# Camden Lock Village / Hawley Wharf

R016 - Area D Non Material Amendment Application

## 4.0 Area D

### 4.8 Proposed Scheme - First Floor Plan

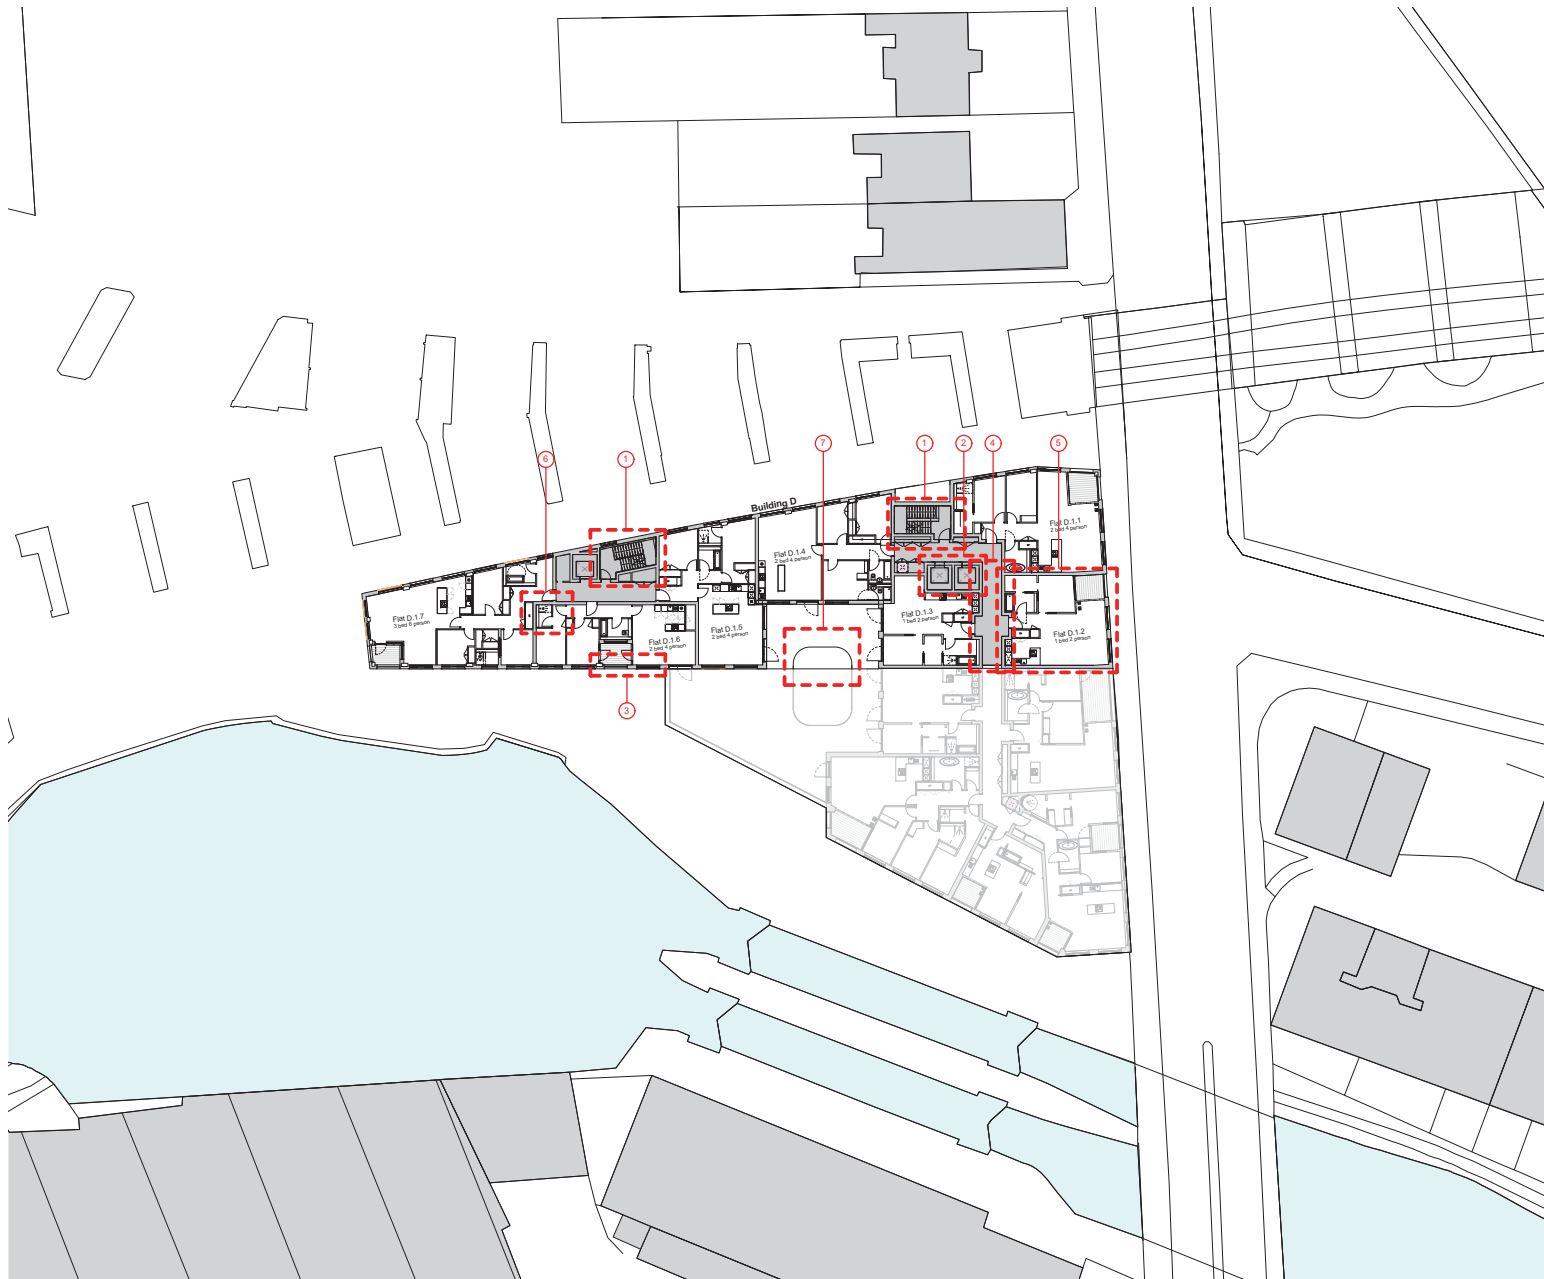
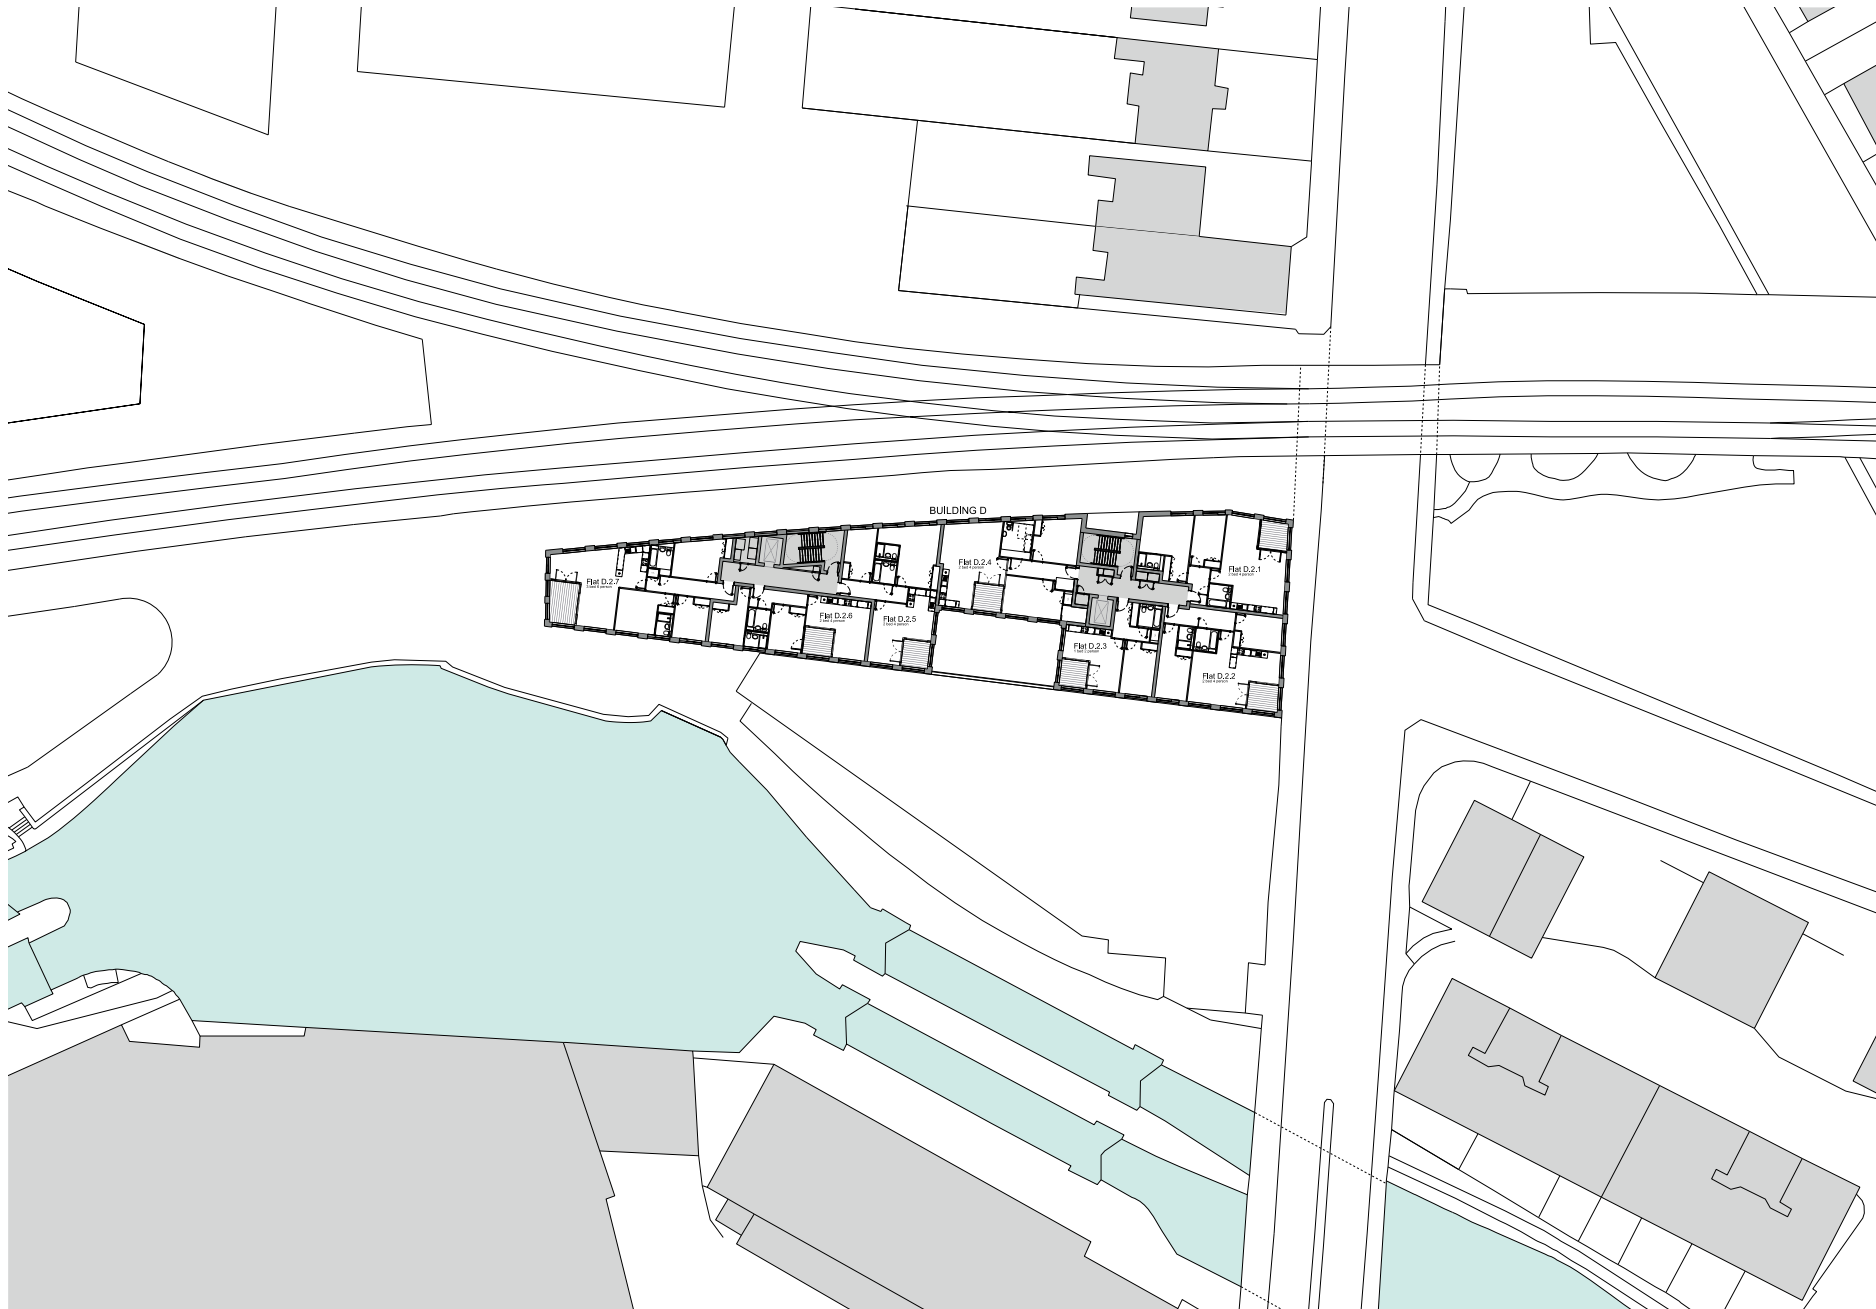
- ① Core revised and stair flipped to provide space for risers as per MEP service strategy
- ② Liftcore increased to accommodate Area E
- ③ Balcony and window mirrored to align with internal layout
- ④ Common corridor extended to accommodate Area E
- ⑤ Flat D.1.2 changed from 2 bed 4 person to a 1 bed 2 person apartment
- ⑥ New riser for cafe kitchen extract
- ⑦ Rooflight added to allow natural light to employment space (shape and size to be confirmed)

- Structure added to plans
- Utility cupboards added to all flats as per updated MEP strategy

### 4.12 Proposed Scheme - Third Floor Plan

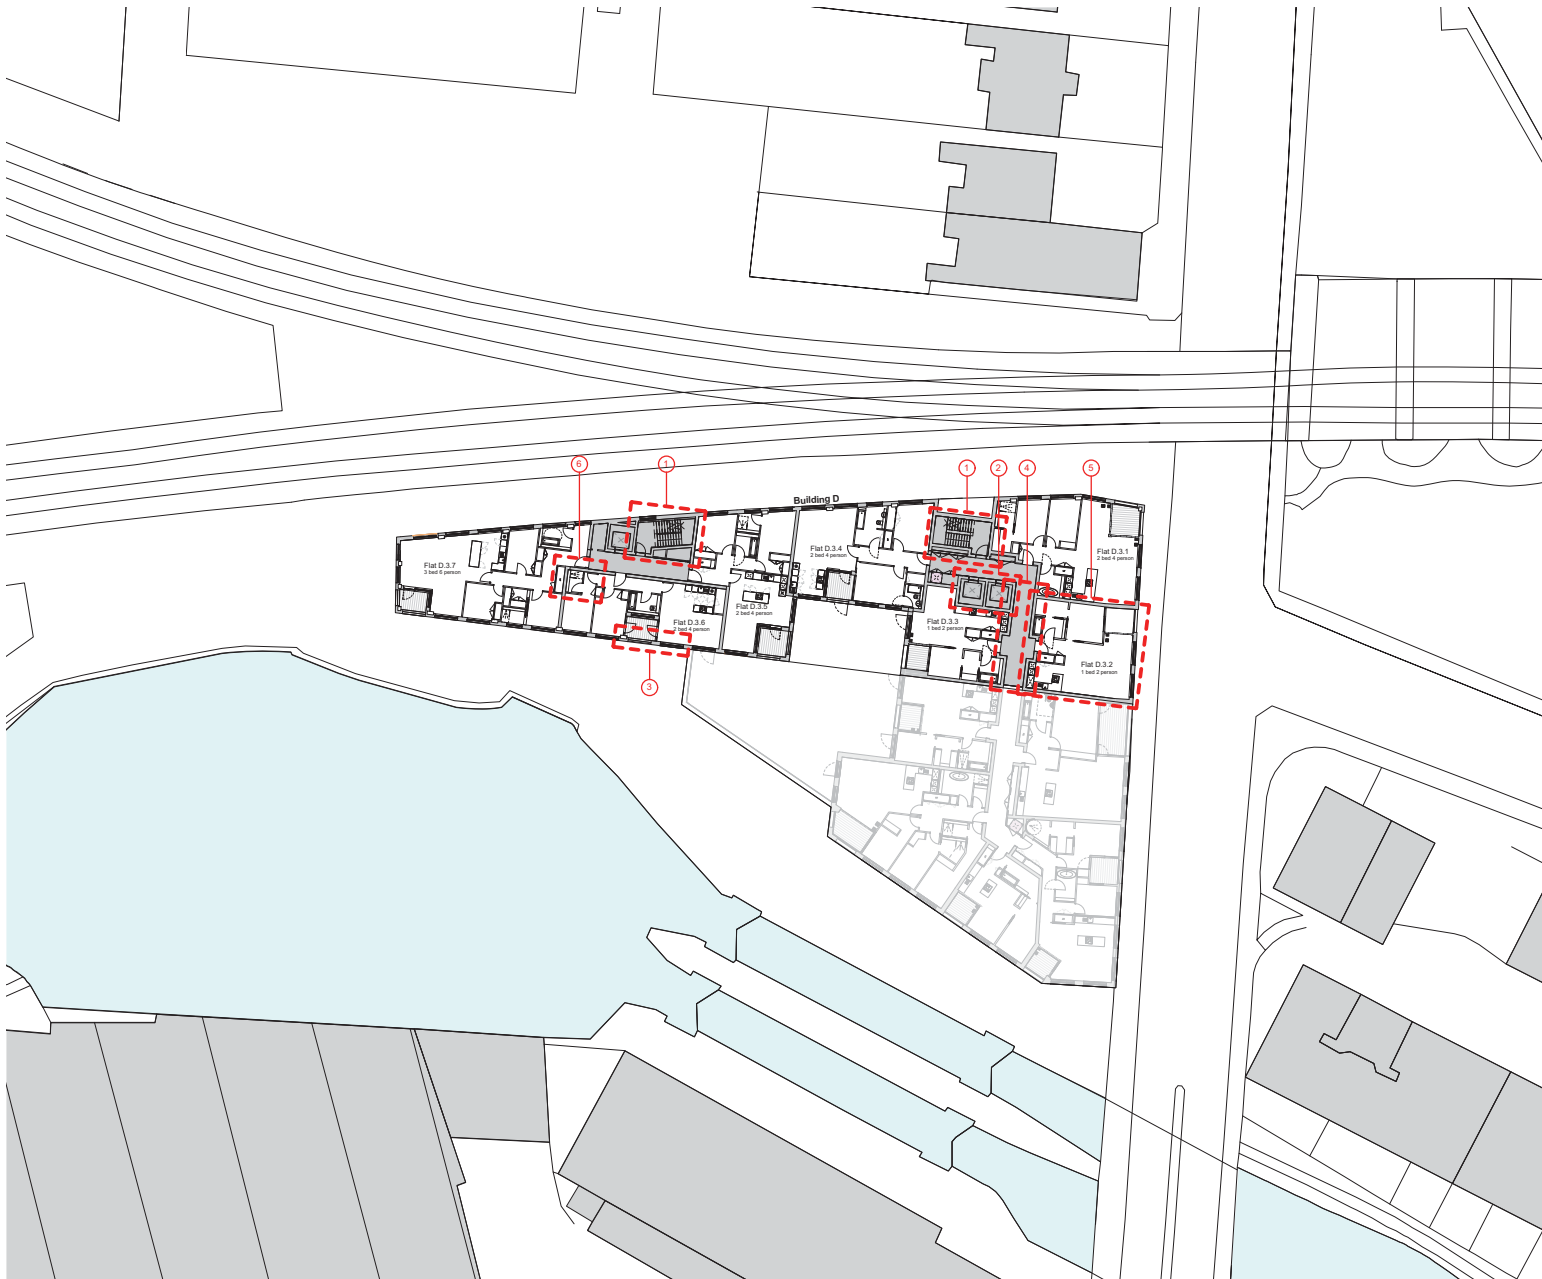
- ① Core revised and stair flipped to provide space for risers as per MEP service strategy
- ② Liftcore increased to accommodate Area E
- ③ Balcony and window mirrored to align with internal layout
- ④ Common corridor extended to accommodate Area E
- ⑤ Flat D.3.2 changed from 2 bed 4 person to a 1 bed 2 person apartment
- ⑥ New riser for cafe kitchen extract

- Structure added to plans
- Utility cupboards added to all flats as per updated MEP strategy

### Proposed Scheme - Fourth Floor Plan

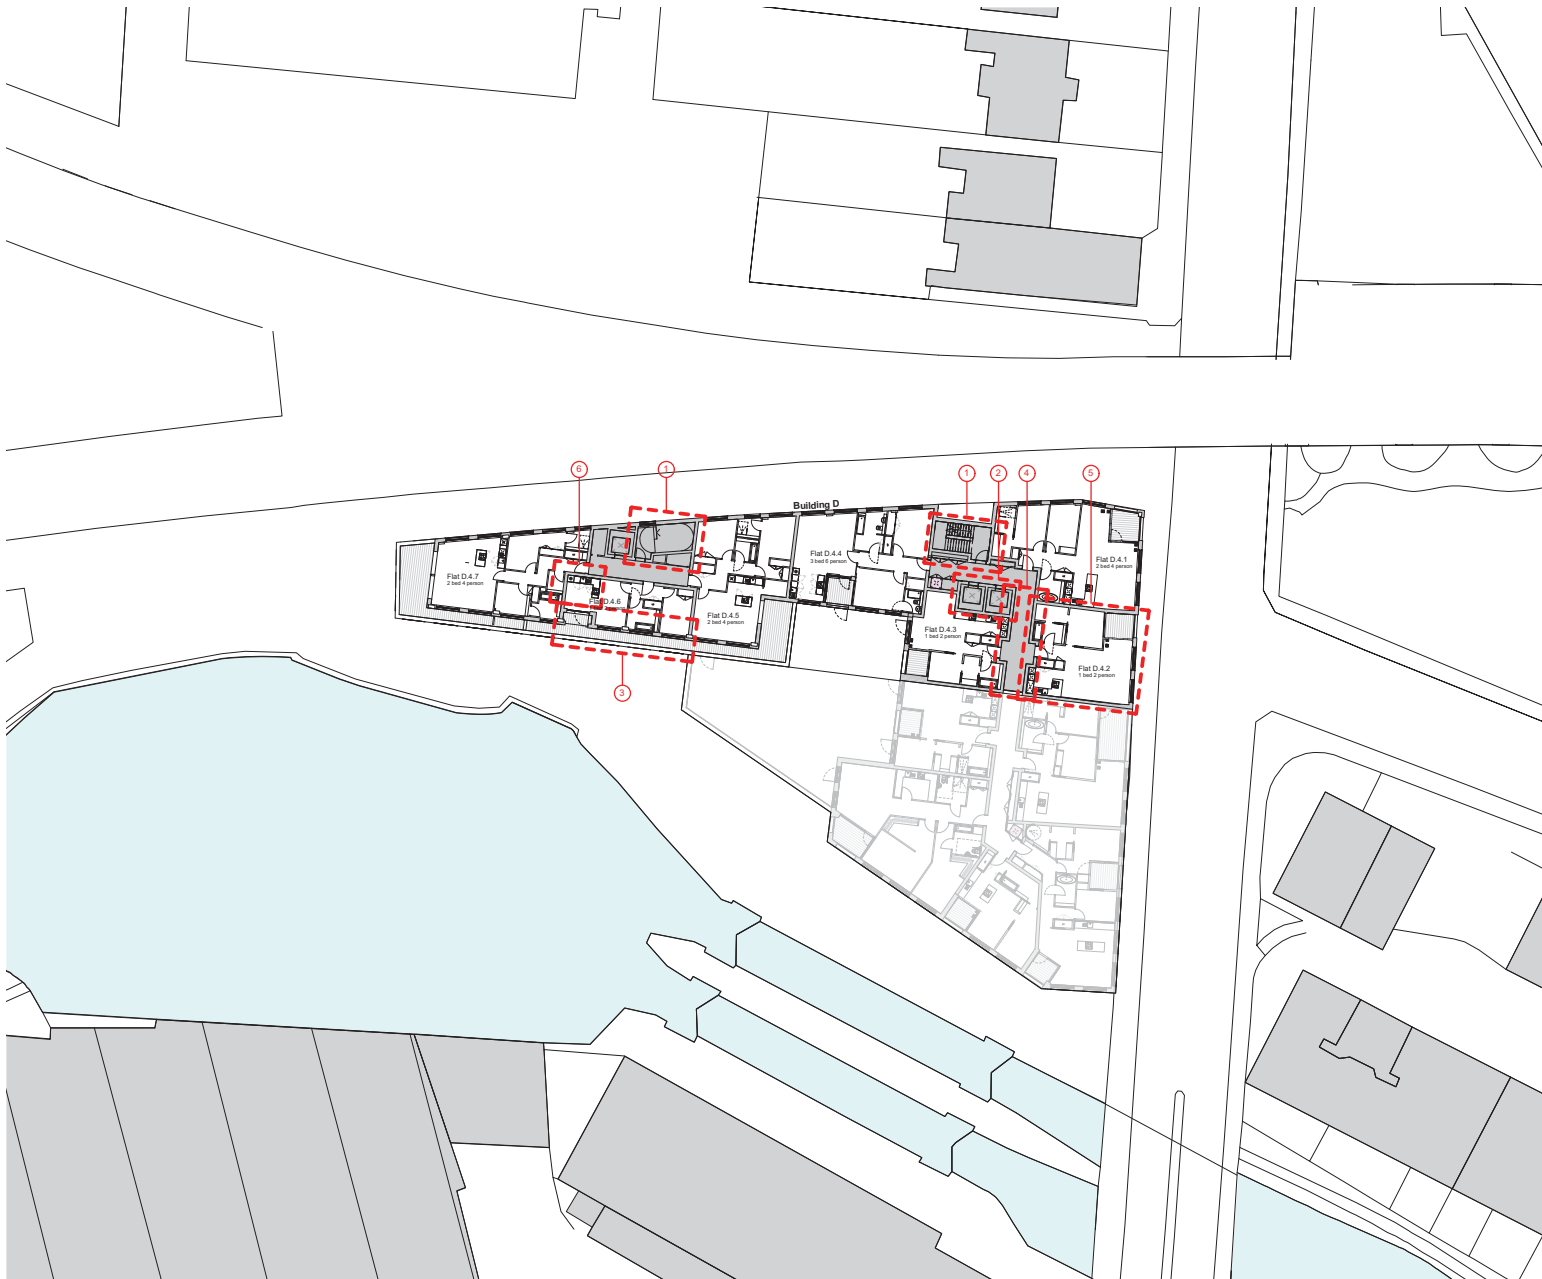
- ① Core revised and stair flipped to provide space for risers as per MEP service strategy
- ② Liftcore increased to accommodate Area E
- ③ Balcony and window mirrored to align with internal layout
- ④ Common corridor extended to accommodate Area E
- ⑤ Flat D.4.2 changed from 2 bed 4 person to a 1 bed 2 person apartment
- ⑥ New riser for cafe kitchen extract

- Structure added to plans
- Utility cupboards added to all flats as per updated MEP strategy
